Re: Agnico Response to CIRNAC Inspection Report June 20, 2022

Agnico Eagle Mines (**Agnico**) is providing this letter in response to actions items identified in the Inspection Report provided by Crown Indigenous Relations and Northern Affairs Canada under the Type A Water License (2AM-DOH1335). Please note the inspection report mentioned the license 2AM-DOH-1323, this water license and amendments have been incorporated, when appropriate, in the license 2AM-DOH-1335. Agnico's responses including timeline for implementation are detailed below:

Photo 1: Previously packaged waste oil in lined seacans, located at Roberts Bay Waste Management

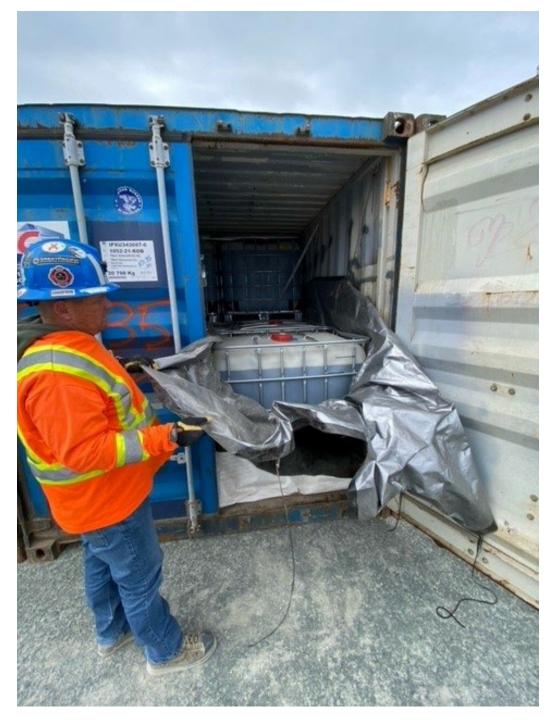
- The inspector is requesting the licensee explain where the "lined containment at the
 waste at the waste storage facility is and ensure all waste is managed and contained
 in a way approved by the NWB. The licensee appears to have failed to properly store
 Waste fuels, Glycol and Consumable Chemicals, based upon the information in "Table
 4.0-1, of the Hope Bay Project Hazardous Waste Management Plan" which states the
 following;
 - Waste Fuels will be stored in "Steel containers stored within lined containment at Waste Management Facility.
 - Glycol(antifreeze) will be stored in "stored within lined containment at the Waste Management Facility.
 - Consumable Chemicals and Packaging (e.g. Process Plant chemicals, Wastewater Treatment Plant chemicals) will be stored in "Waste chemicals and plastic packaging stored within sea cans or lined containment at Waste Management facility"

For managing hazardous waste material, waste management personnel has used seacan liners to ensure that liquid hazardous waste are within a lined containment at the waste storage facility, see photo 1.

To formalize this practice and ensure consistency, the operating procedure "Packaging and Labeling of Waste Materials" will be updated to require the installation of a seacan liner prior to packaging hazardous liquids for backhaul including spent or expired fuels. This will be completed by September 7, 2022.

In addition, the "Hope Bay Project Hazardous Waste Management Plan" will be updated to clarify that the lined containment at the waste storage facility could be within the seacans and not just a lined facility in which to stored unlined seacans. The Management Plan will be updated and submitted with the 2022 Annual Report submission in March 2023
